SERVICE BULLETIN

Bulletin No: JC-022-12 REV1

Product Type: G, H & J series ProCat and Predator-Pro

Customer Issue: Premature deck belt failure. (Belt failing in the initial 100 hours of use.)

This kit will include:

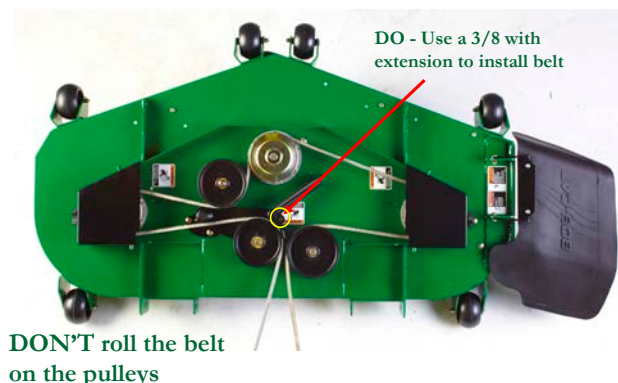
Cause: Idler spring tension too high, clutch engagement too abrupt.

Action Required: For units that experience premature belt failure, install idler belt kit **970488** for 52" units or **970481** for 61" units. (It may be required to send failed belt back to the factory for warranty approval)

- 1 revised idler assembly with fixed belt guide,
- 1 stronger cord belt; 4169640 for 52" or 4169463 for 61" (replaces 4165619 or 4165618)
- 1 lighter tensioned spring (this is the same spring 4168493 with the yellow stripe issued earlier)
- 1 newly programmed soft start clutch module with harness (even if the unit already has a soft start clutch module on it, you will still install the new one),
- 1 new spring anchoring plate as adjusting the spring tension is critical to long belt life.
